**Norfolk Vanguard Offshore Wind Farm**

## **Norfolk County Council Unresolved Traffic Matters Position Statement**

Document Reference: ExA; AS; 10.D9.7

Date: 06 June 2019

TITLE  
B1149 TRAFFIC MANAGEMENT

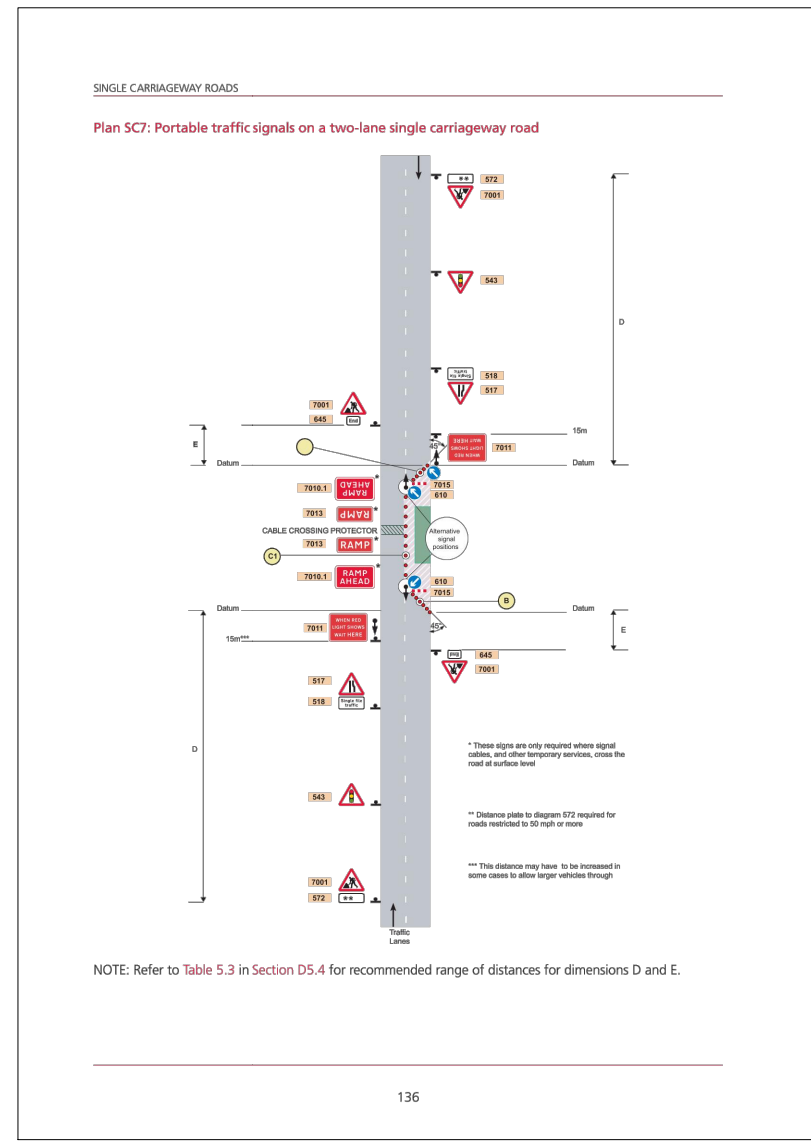
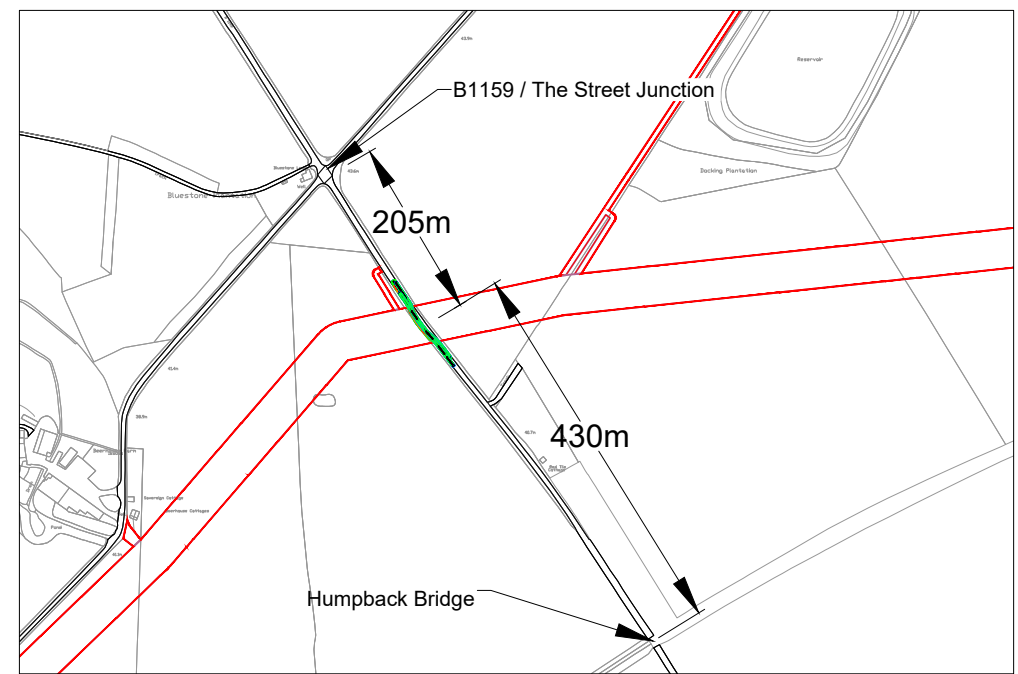
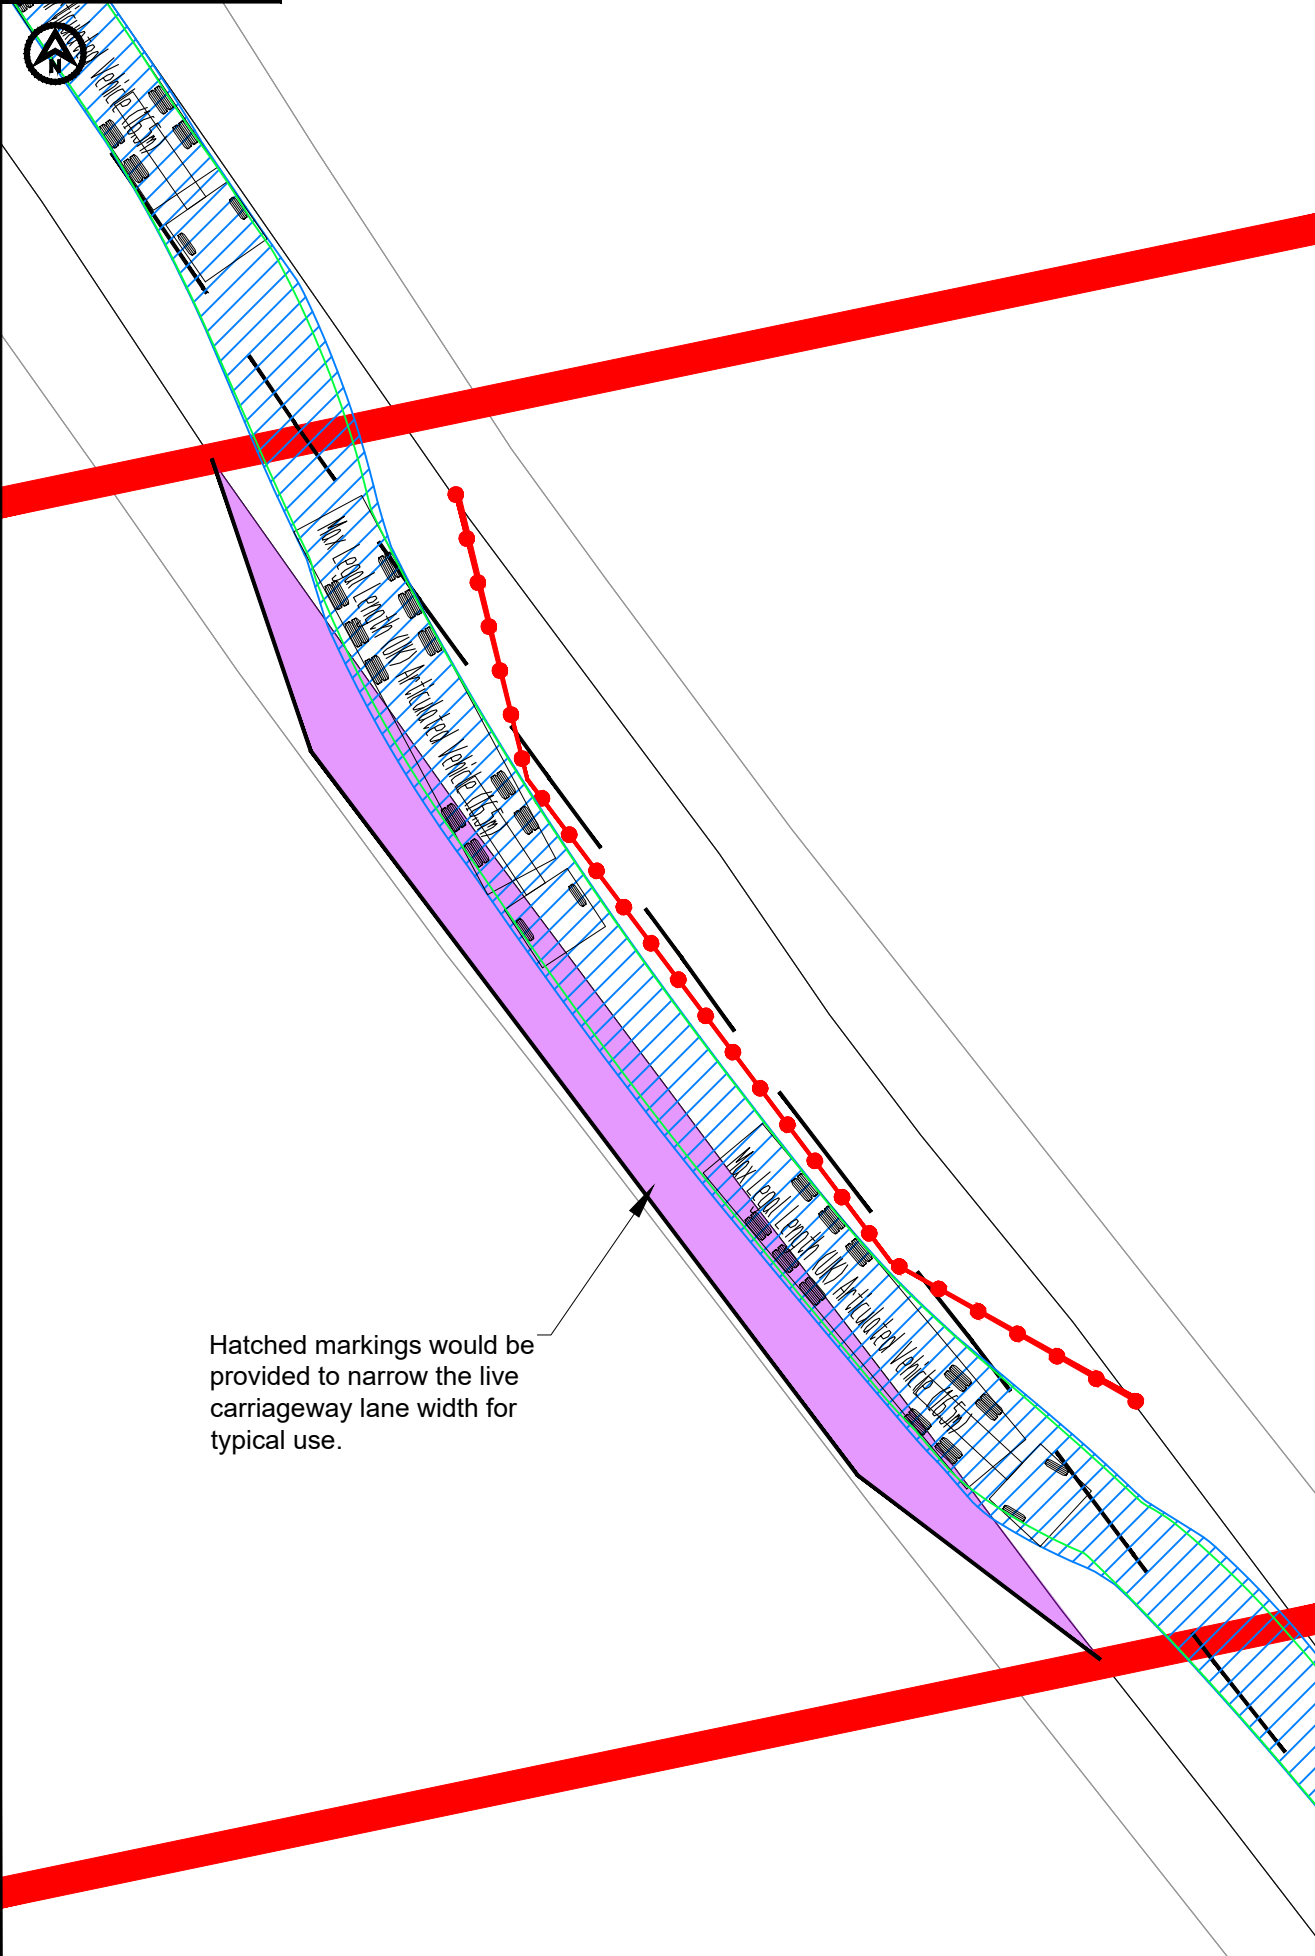
However, the swept path analysis is totally reliant upon a 0.5m safety zone outside the work area. (i.e. the buffer between vehicles and roadworks/the open trench excavation). This is a National Speed Limit road, so should have a 1.2 m safety zone. Whilst this can be reduced with the use of a Temporary 30mph Speed Restriction, it is not so in the case of the excavation exceeding 1.2 metre depth.

The increased safety zone is related to the potential for trench shoring and consideration for ground conditions and angle of repose in the soil. NCC do not believe this can be mitigated.

In the circumstances irrespective of whether PINS grant consent or not, the applicants cannot proceed with open cut trenching unless they can provide a 1.2m wide safety zone – which at present they cannot do.

In the circumstances NCC must insist that trenchless crossing is used, and **NCC accept no liability should an unsafe method of working be approved by PINS – including any subsequent action for manslaughter.**

The safe working distance of 1.2m can readily be accommodated in the final design of these roadworks. The area of road widening (the pink area shown on the drawings in Appendix A) can be widened further to the west within the Order limits, and the coned off working area can be narrowed from 20m down to 15m if required as there will be no requirement to maintain a running track between the cable trenches. This would provide additional space for vehicles to manoeuvre (combined with extending the road further to the west) to ensure that the swept path remains safely negotiable, whilst at the same time maintaining a safe working area. In addition, speed restrictions can be introduced for vehicles as they traverse the single lane management. Alternatively the 1.5m deep excavation can be designed to provide additional lateral support to minimise the risks associated with working in proximity to deep excavation and ensuring a 0.5m distance of separation would be safe. These options are all within the control of the Applicant and can be readily addressed during detailed design. As Norfolk County Council highlight in their position at the 30.05.2019, land within the highway boundary, outside of the Order limits, would also be available to extend the tapers of the road widening if required, depending on the final design of the roadworks.

The roadworks required for abnormal loads as described will be required for approximately one week. The final design of the proposed roadworks will form part of the final Traffic Management Plan secured under Requirement 21. Any works proposed in this area may not commence until a Traffic Management Plan (including the detailed design of the roadworks proposed along the B1149) has been submitted to and approved by the relevant planning authority in consultation with the highway authority, i.e. approval from Norfolk County Council as Local Highway Authority of the detailed design of these roadworks will be required post-consent before the works can proceed.

It should be noted that no temporary works areas are included within the current Order limits in proximity to the B1149. As such it would not be possible to undertake a trenchless crossing in this location without additional land outside of the current Order limits. However, the Applicant remains firmly of the view that an open cut trench crossing is

TITLE  
 B1149 TRAFFIC MANAGEMENT  
 ARTICULATED LORRY SWEEP PATH ANALYSIS

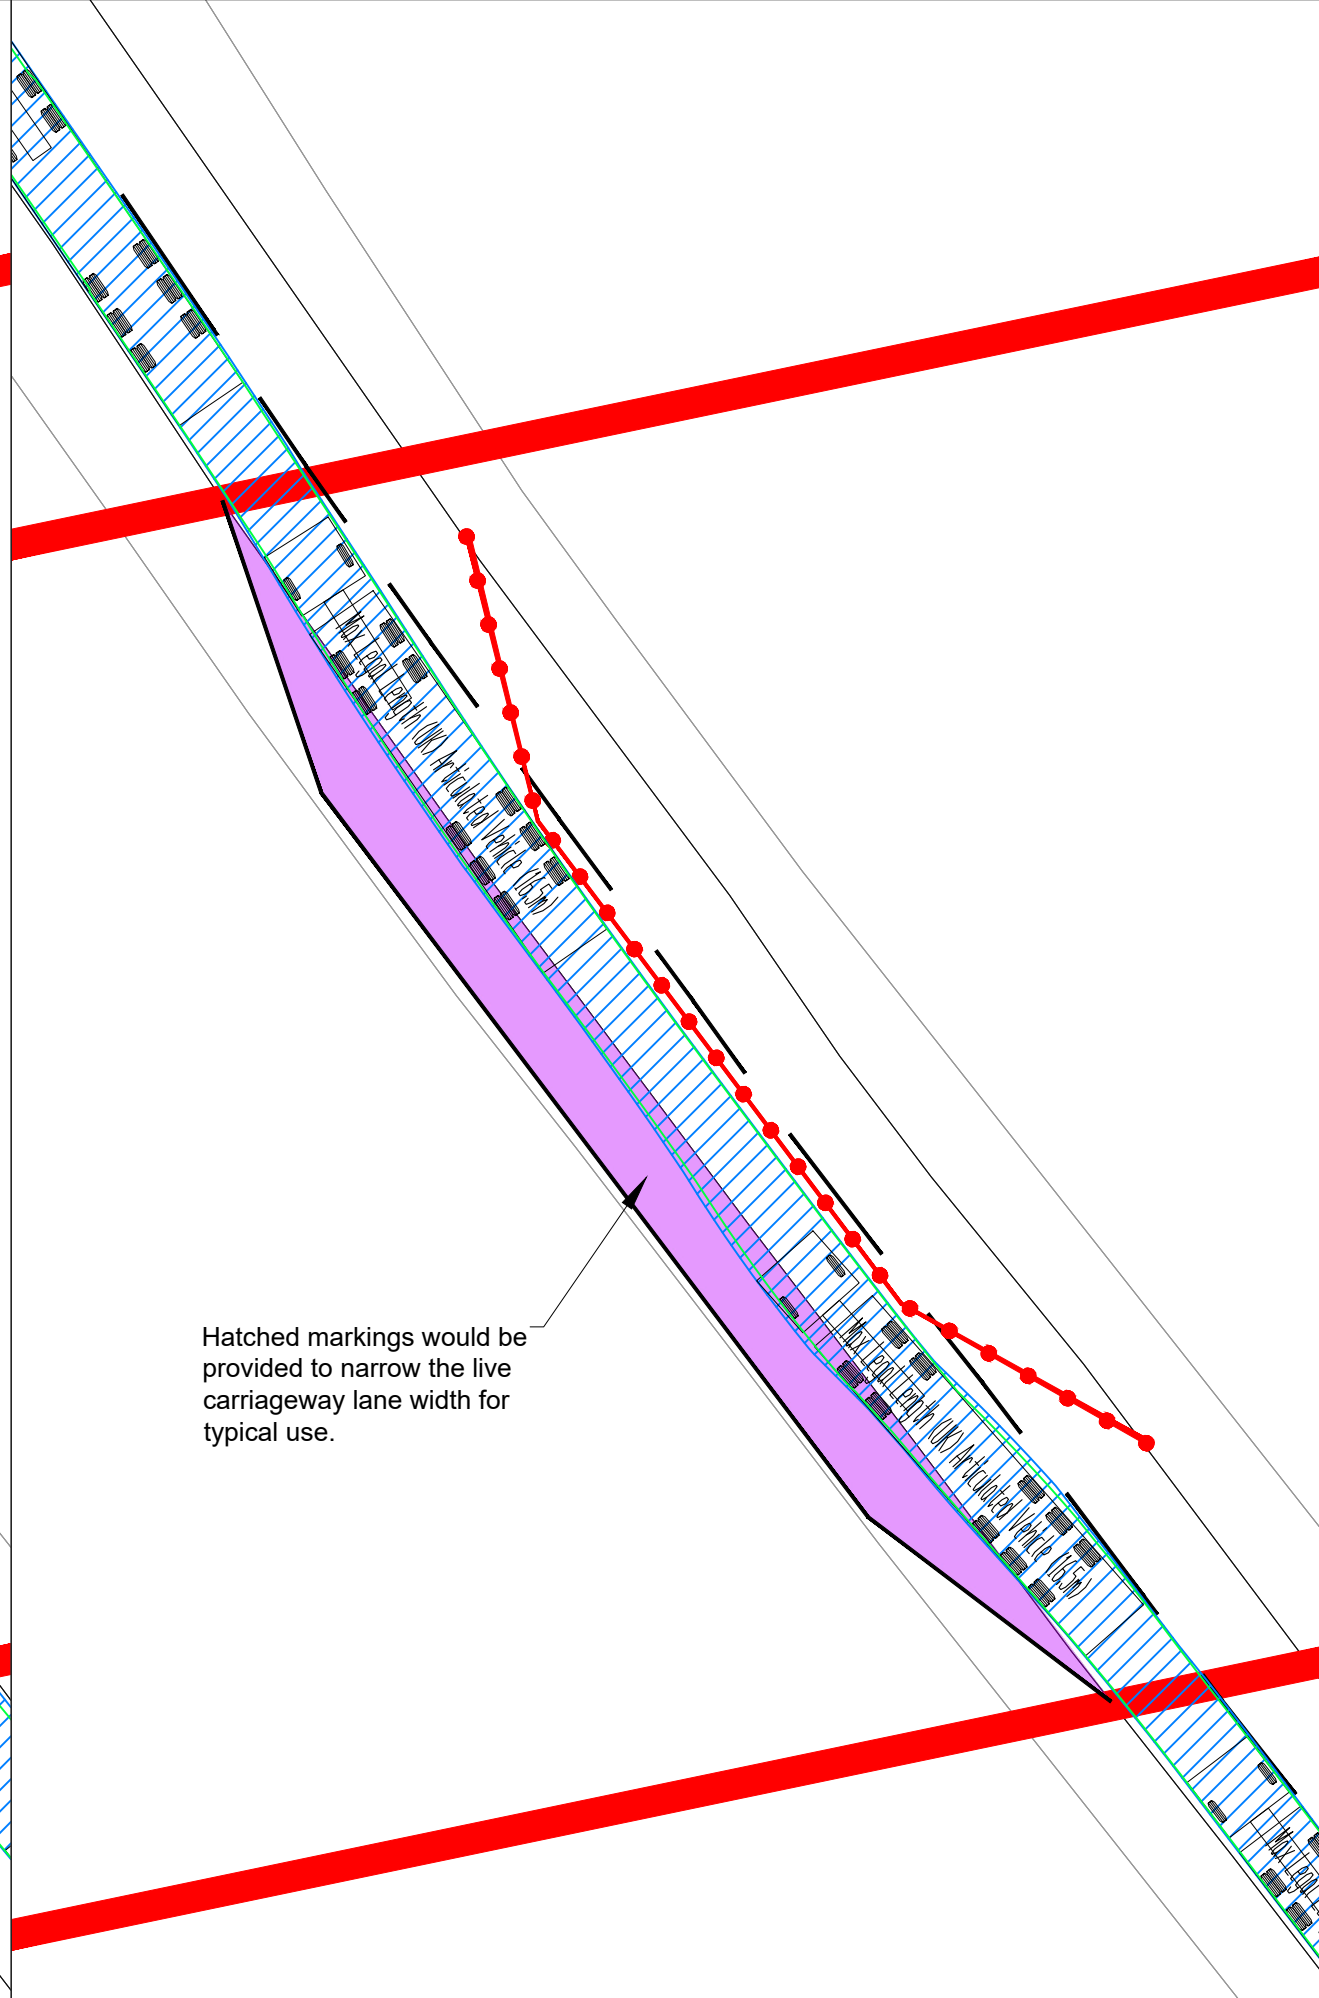
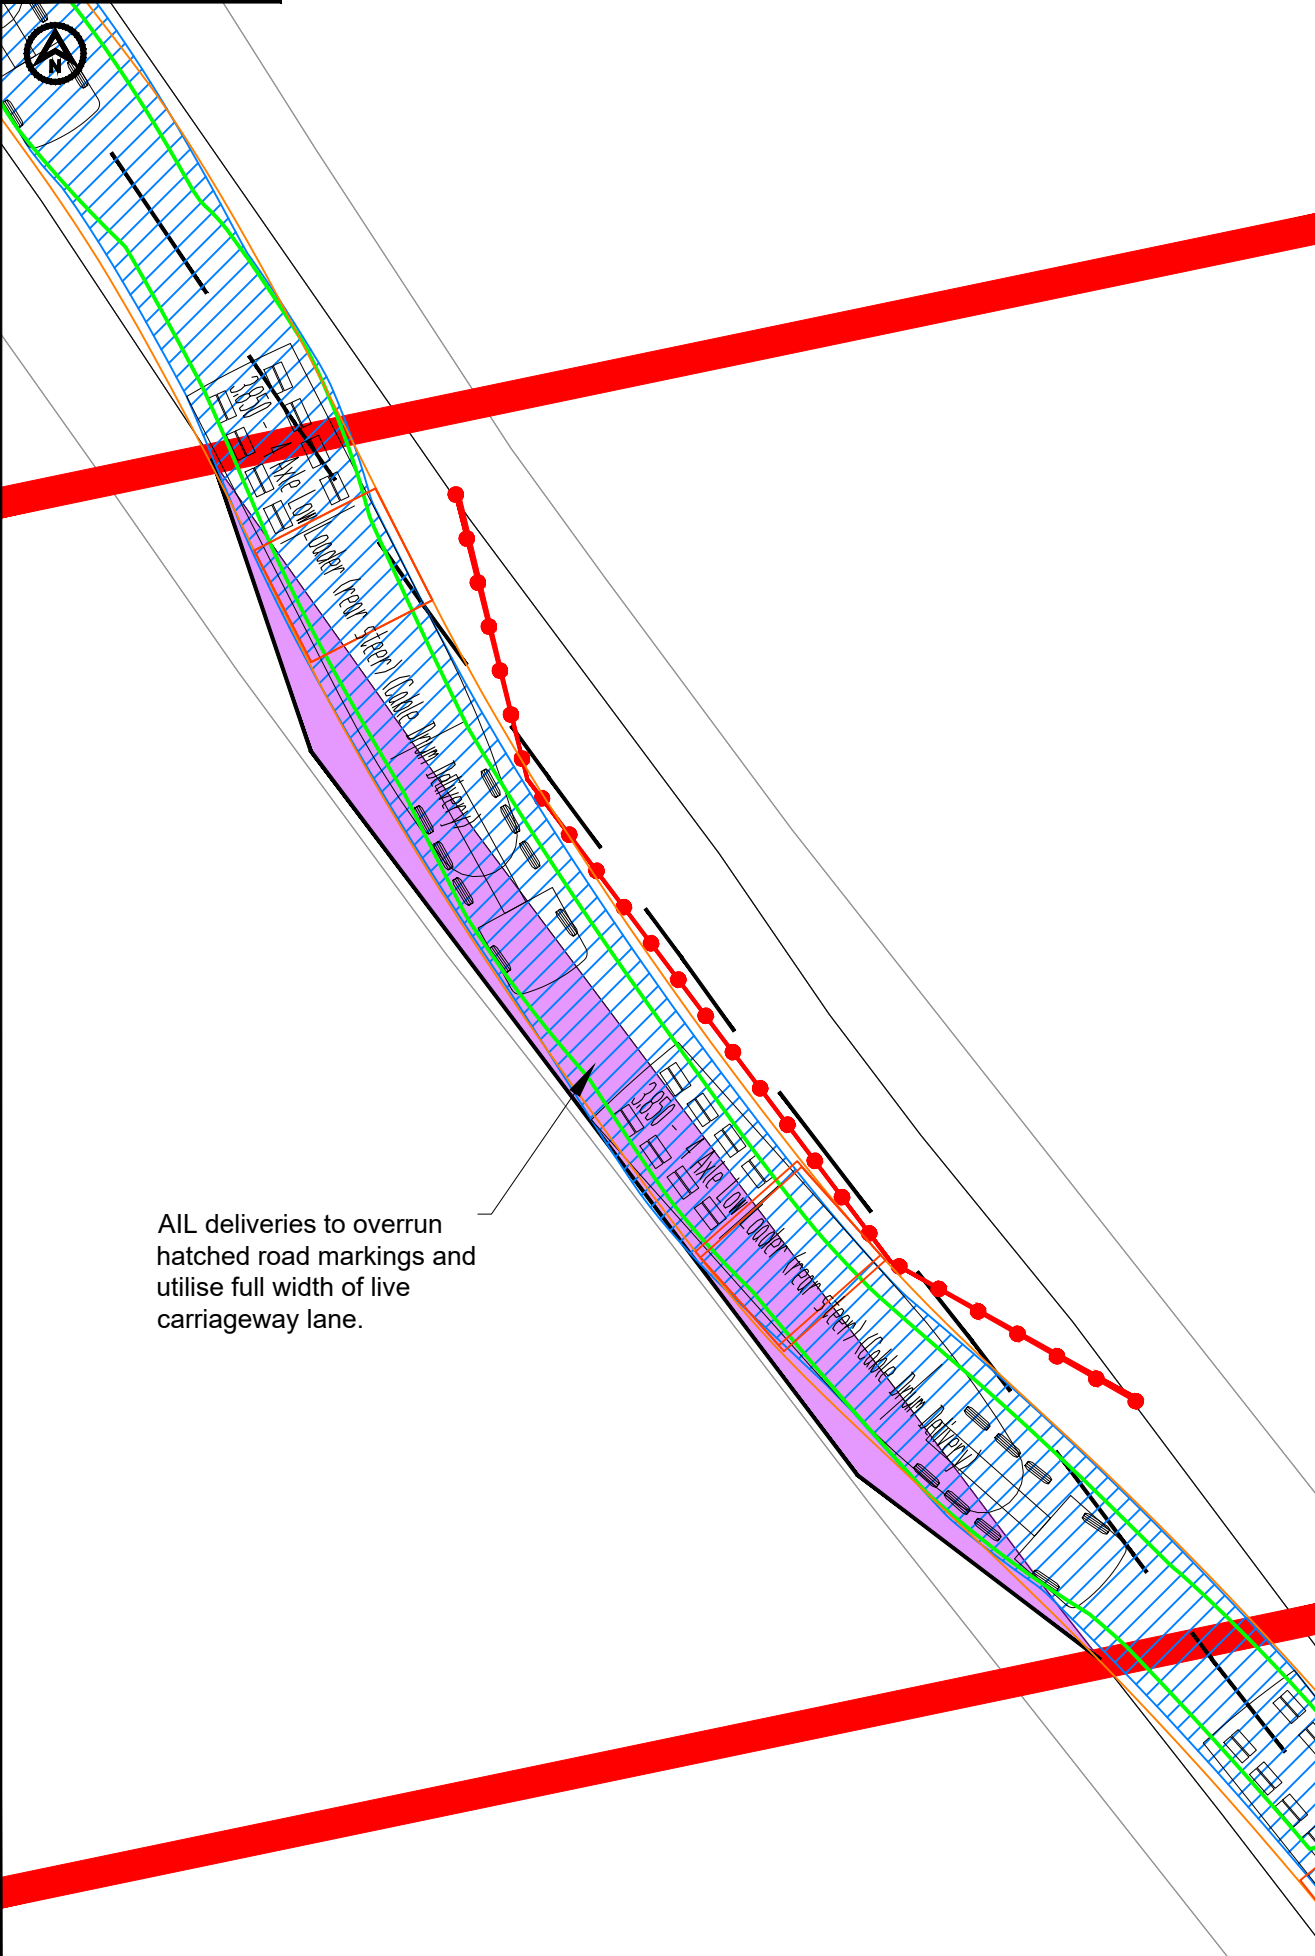
The swept path analysis does indicate that large, articulated vehicles will be able to negotiate the works area, albeit with very little clearance.
